addendum

No.	01	**Project:**	WCFPD Station 1
Date:	September 16, 2025	**Project No:**	025-2125

Modifications to Construction Drawings:

1 A121 REFLECTED CEILING PLAN - WEST
3/16" = 1'-0"

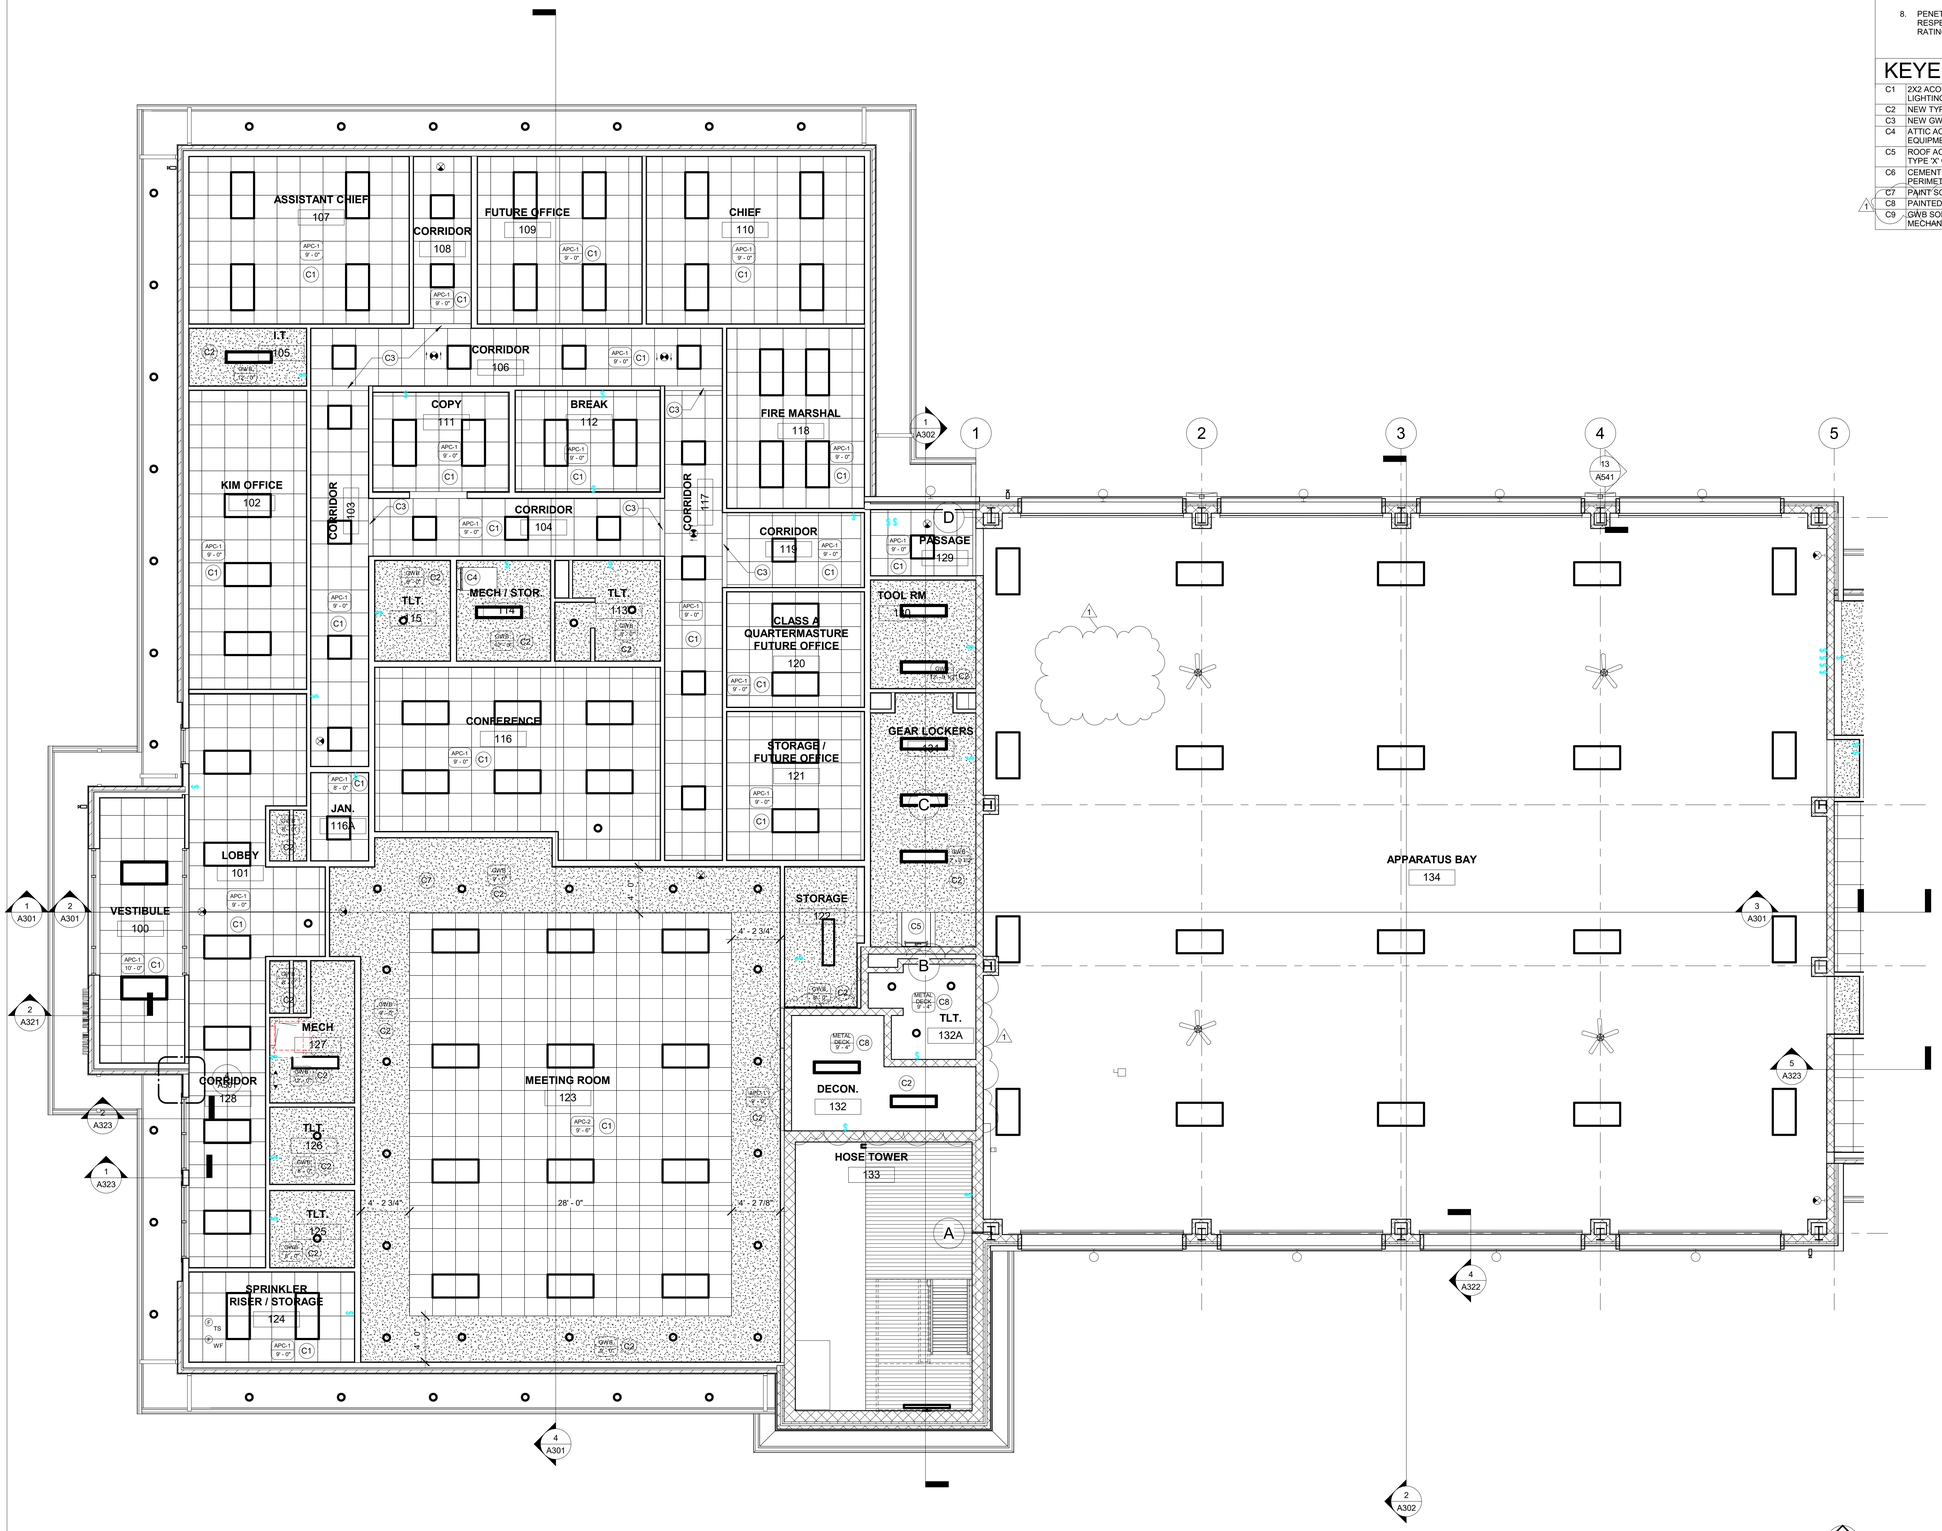
5) Sheet A121 – PARTIAL REFLECTED CEILING PLAN – WEST
   a. REVISE the ceiling in Decon 132 and Decon Tlt. 132A.
   b. ADD Keyed Notes C8 and C9.
   c. REMOVE ceiling fan in west bay of app bay.

1 A141 ROOF PLAN - WEST
3/16" = 1'-0"

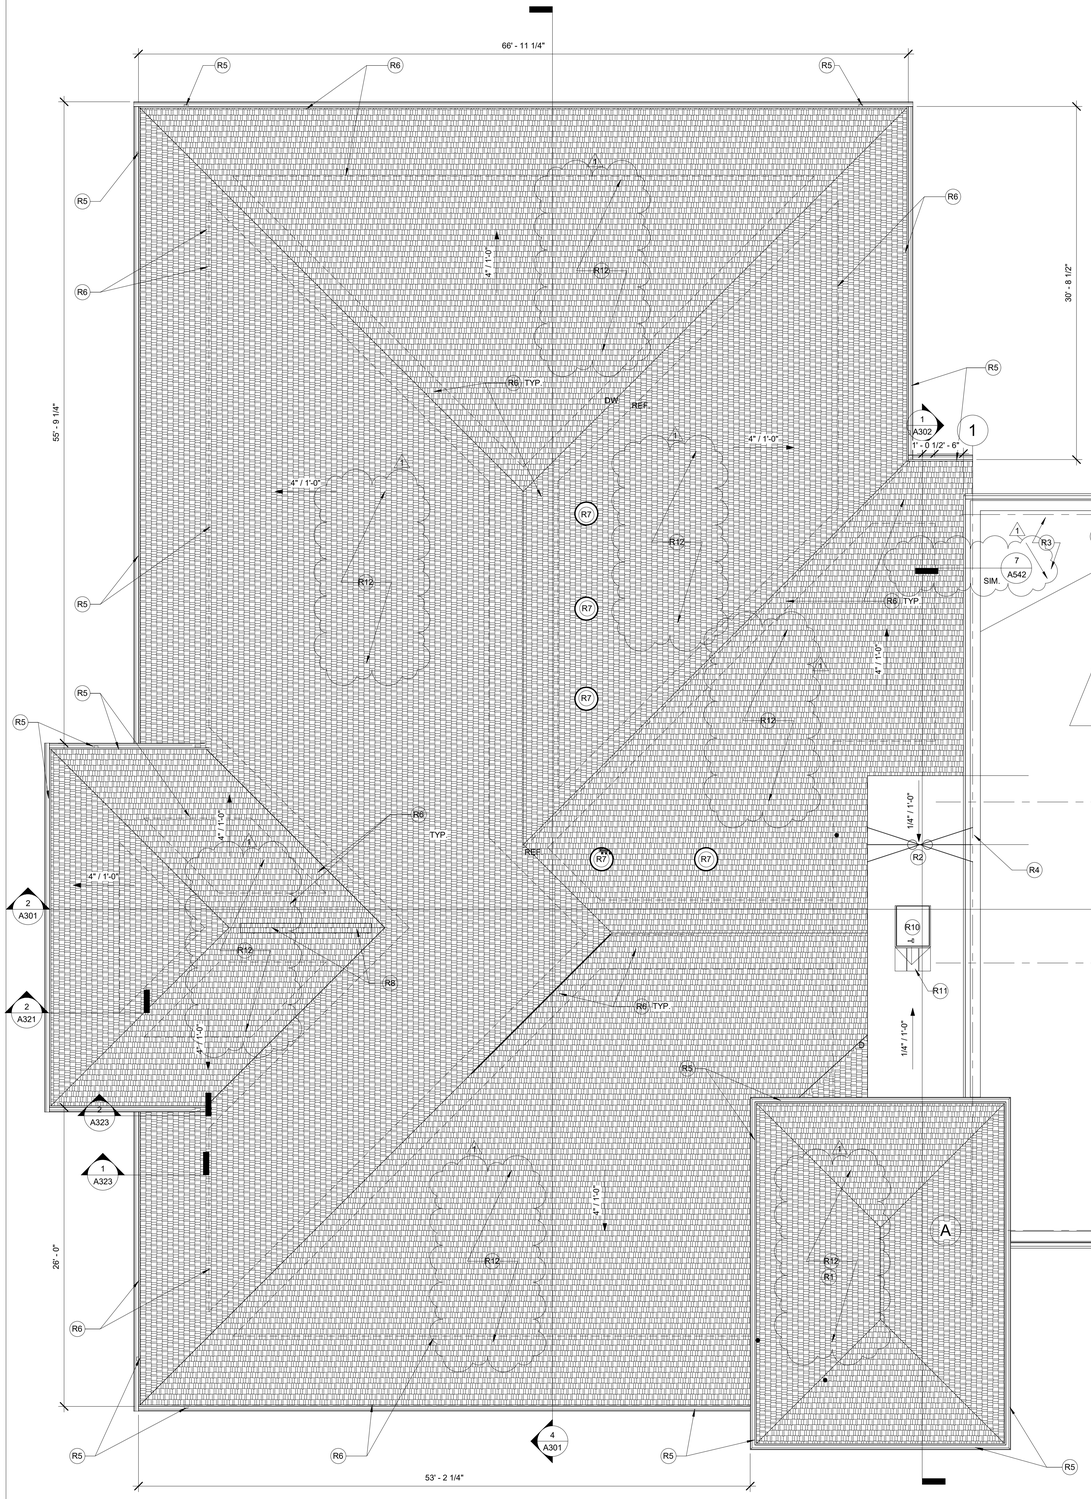
7) Sheet A141 – PARTIAL ROOF PLAN – WEST
   a. REVISE administration and hose tower roofs to be noted as shingles.
   b. ADD section cut 5/A323.
8) Sheet A142 – PARTIAL ROOF PLAN – EAST

1 A201 NORTH ELEVATION
3/32" = 1'-0"

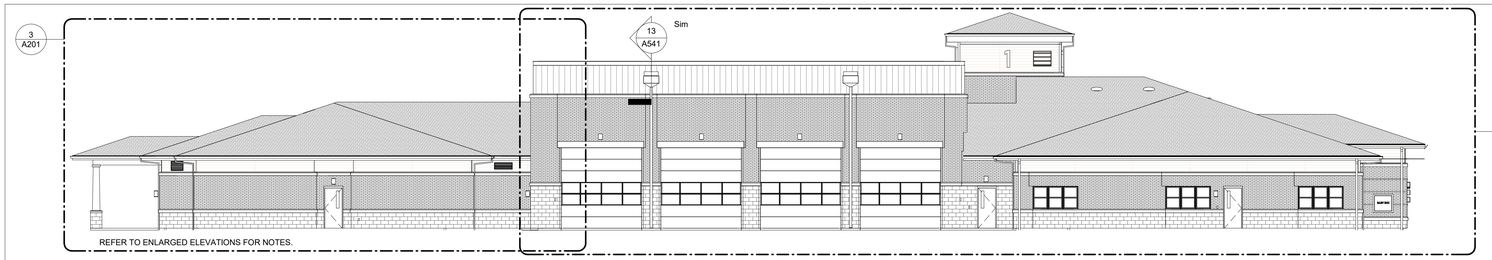
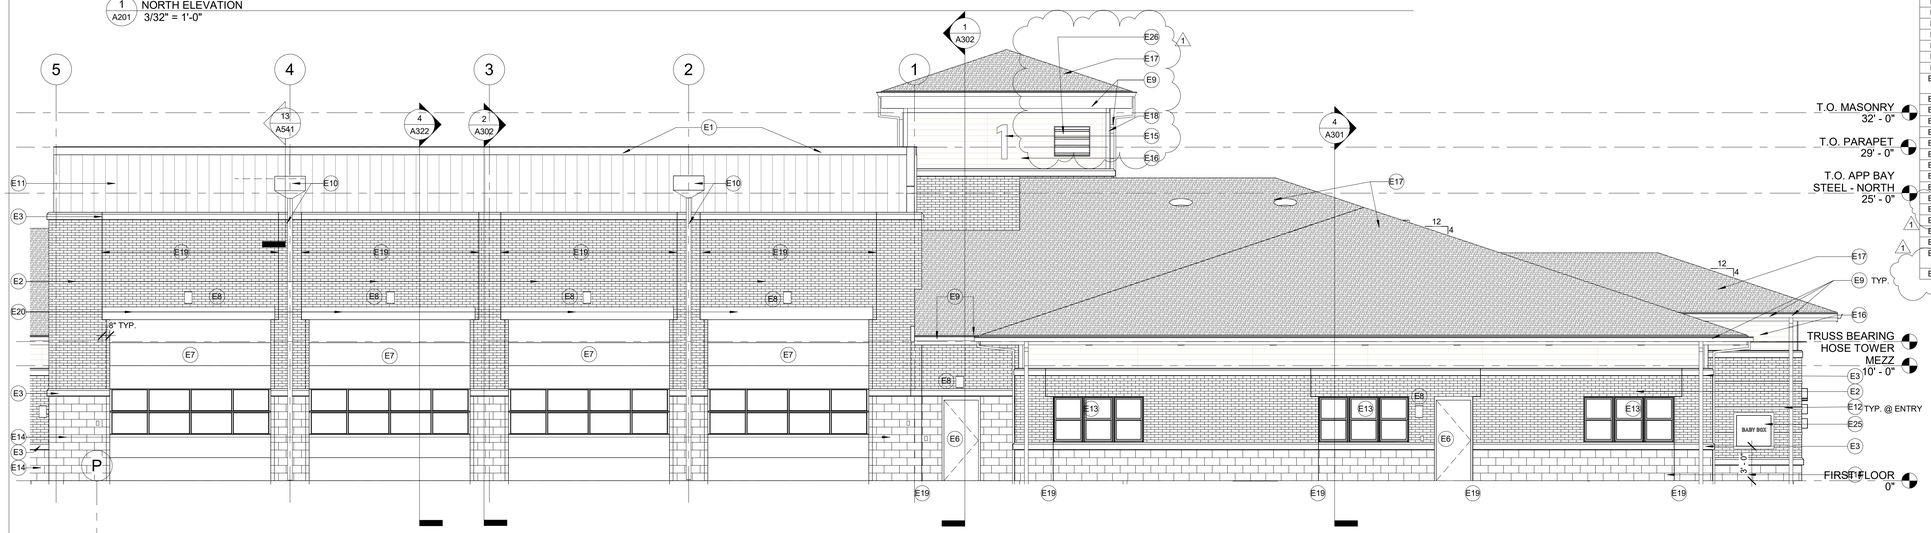
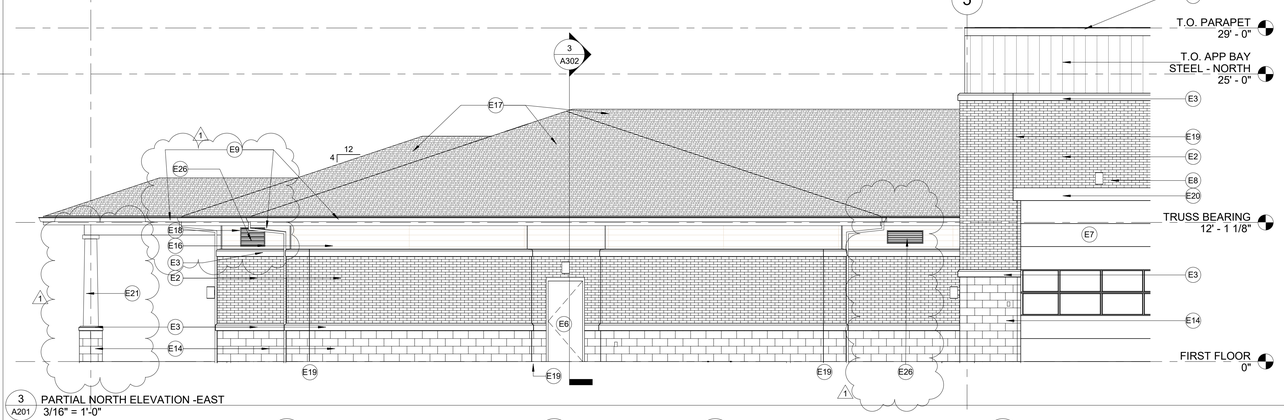
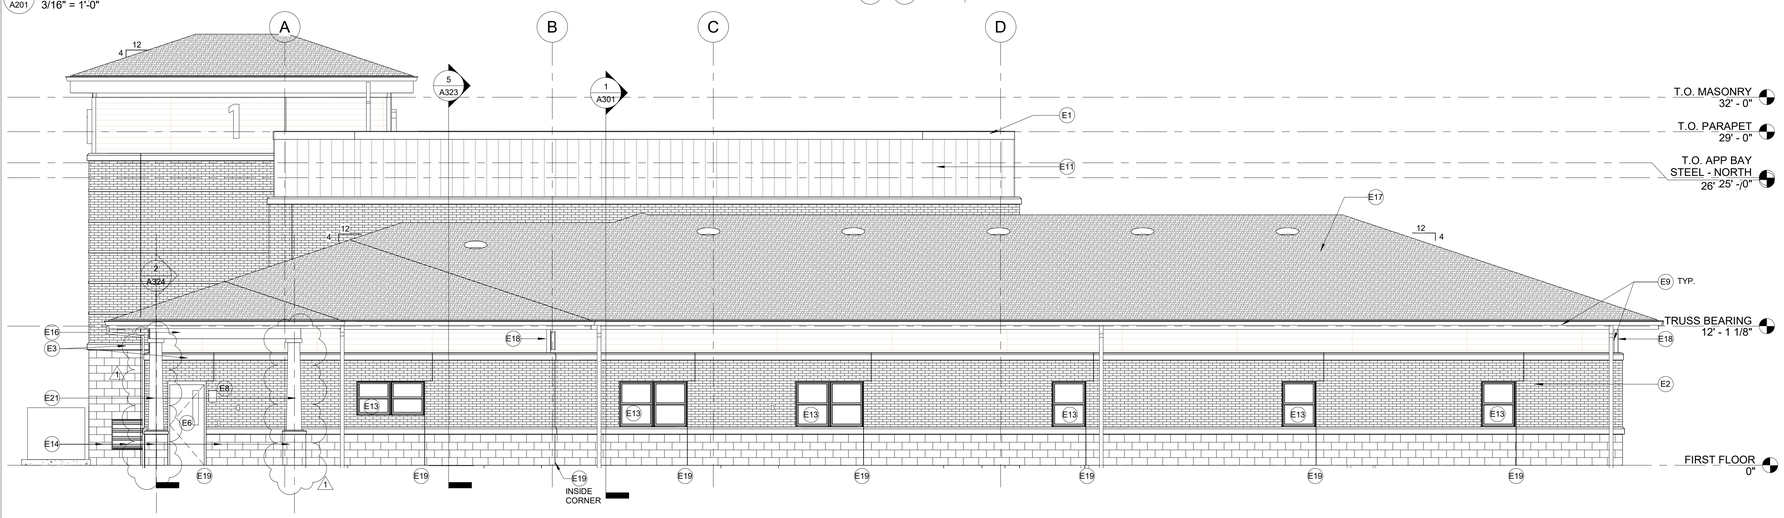
9) Sheet A201 – EXTERIOR ELEVATIONS
   a. ADD Keyed Note E26 and ADD the louver locations to the elevations.
   b. REVISE Keyed Note E21 and modify the columns and piers in the elevations.

1 A202 SOUTH ELEVATION
3/32" = 1'-0"

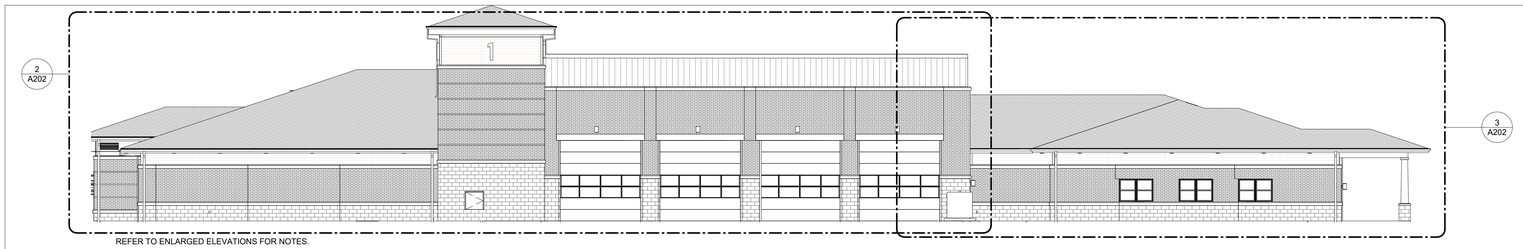
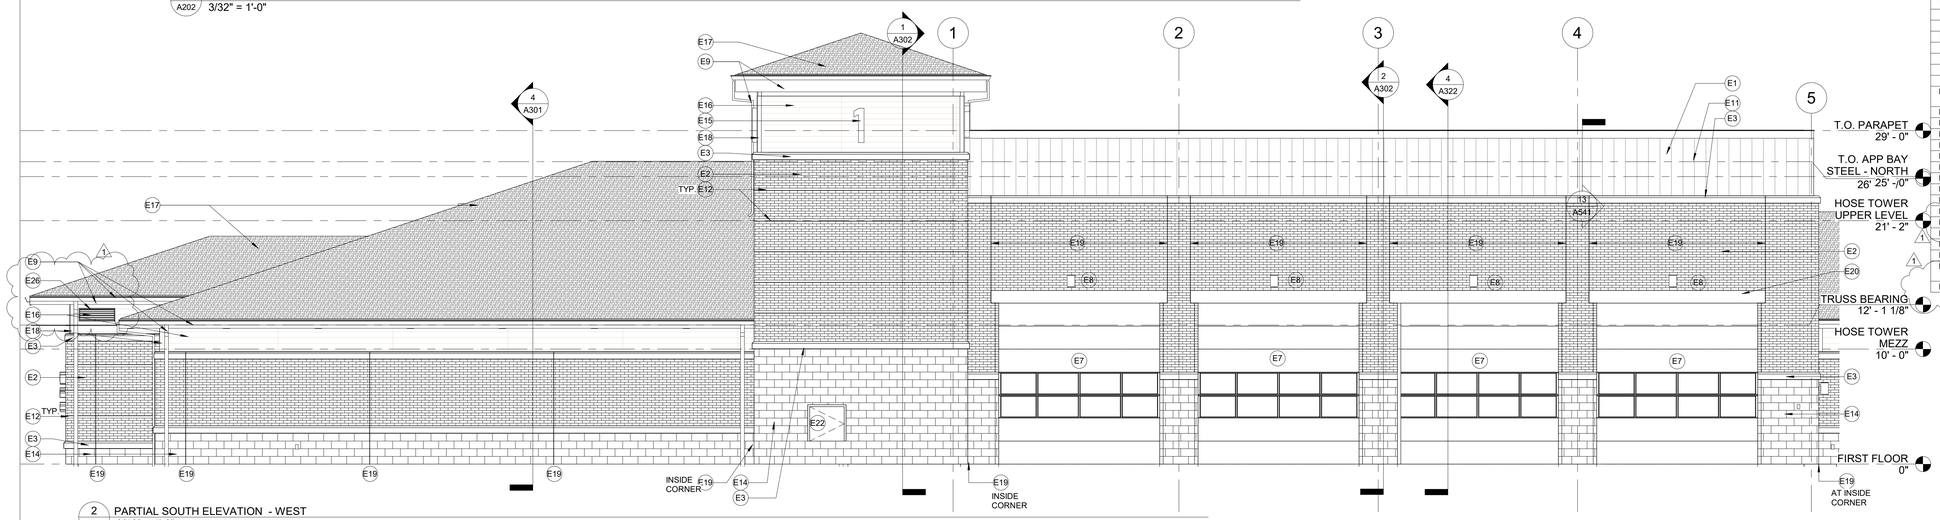
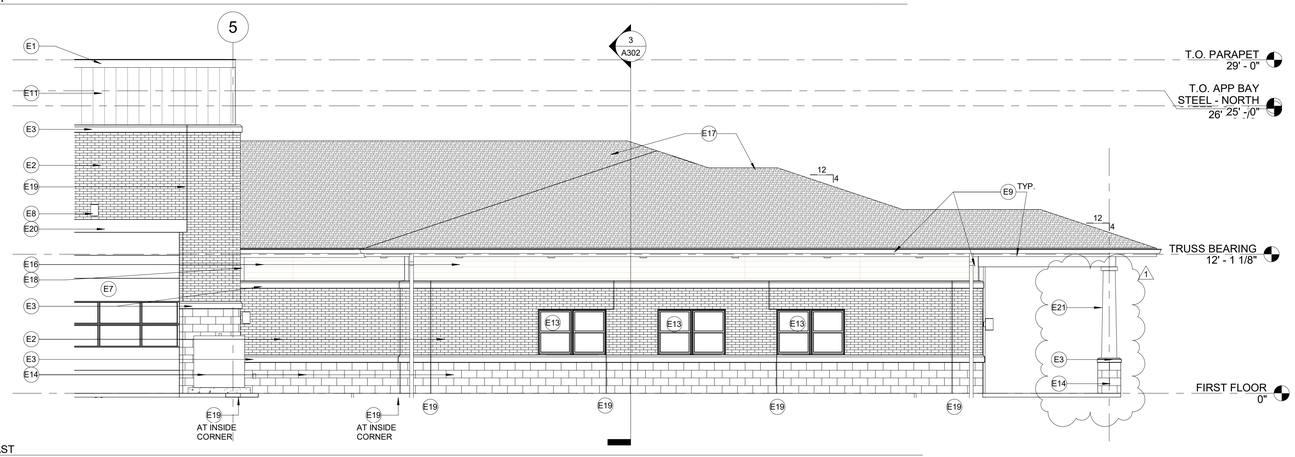
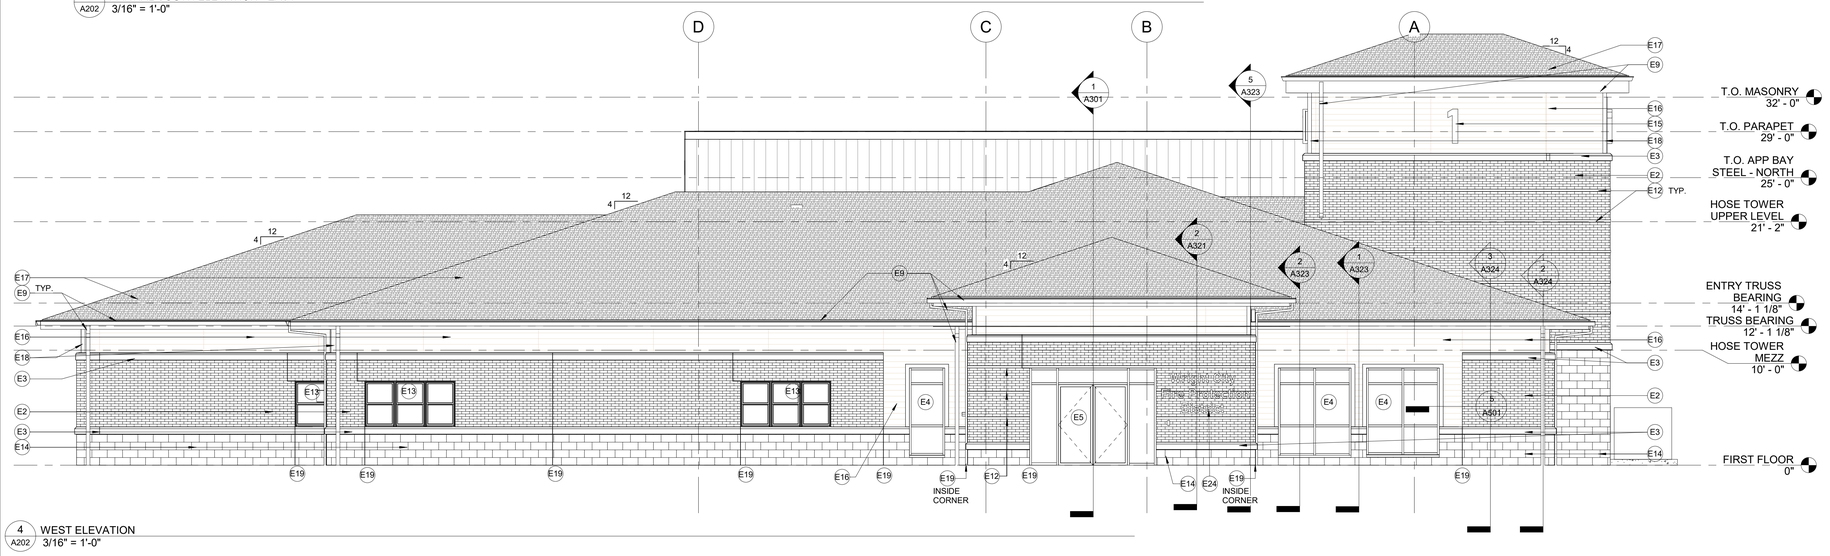
10) Sheet A202 – EXTERIOR ELEVATIONS
   a. ADD Keyed Note E26 and ADD the louver locations to the elevations.
   b. REVISE Keyed Note E21 and modify the columns and piers in the elevations.

10 A223 DISPLAY CASE SECTION/DETAILS
1" = 1'-0"

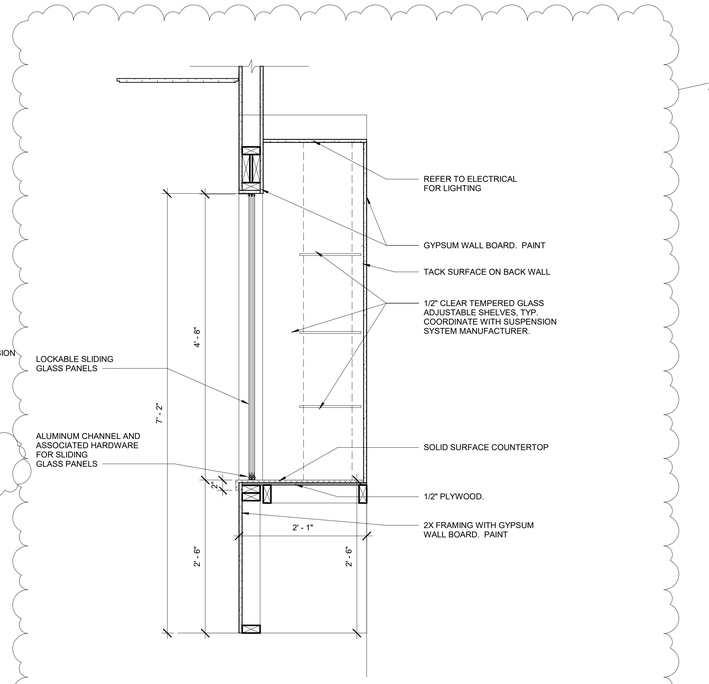
14) Sheet A223 – INTERIOR ELEVATIONS AND DETAILS
    a. ADD Interior Elevation General Note 18.
    b. REVISE Display Case Sections/Details 10/A223.
    c. ADD Keyed Notes E69 and E70.
